Memorandum

Subject: Douglas 234 Filing 5 Minor Development Plat – Engineering 2nd Review

Figure 3C-1. Example of Markings for Approach and Circulatory Roadways at a Roundabout

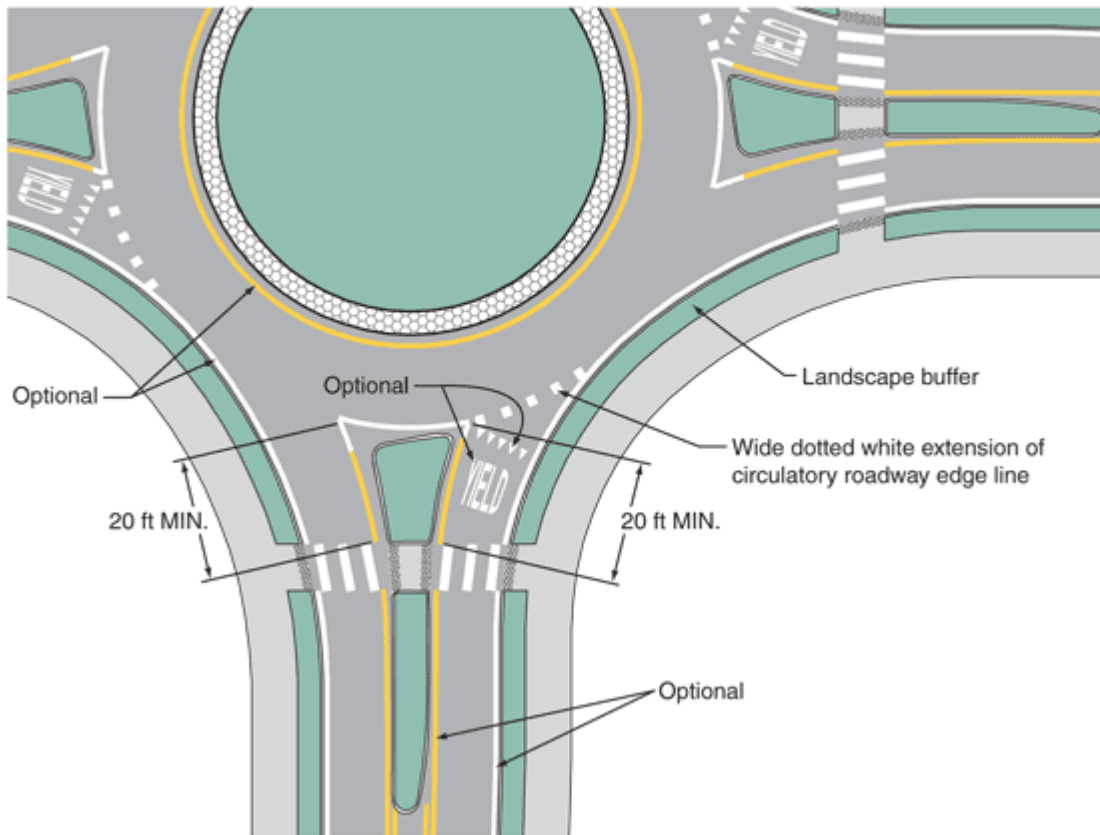
2. Please confirm that it is not the intention to grade separate the lots. The overlot grading plan shows several cross-sections with berms that are not reflected in the contours.
3. Revise the “shark tooth” striping to be perpendicular to the direction of travel as shown below:

Note that the Town will be correcting the east and north legs of the roundabout.
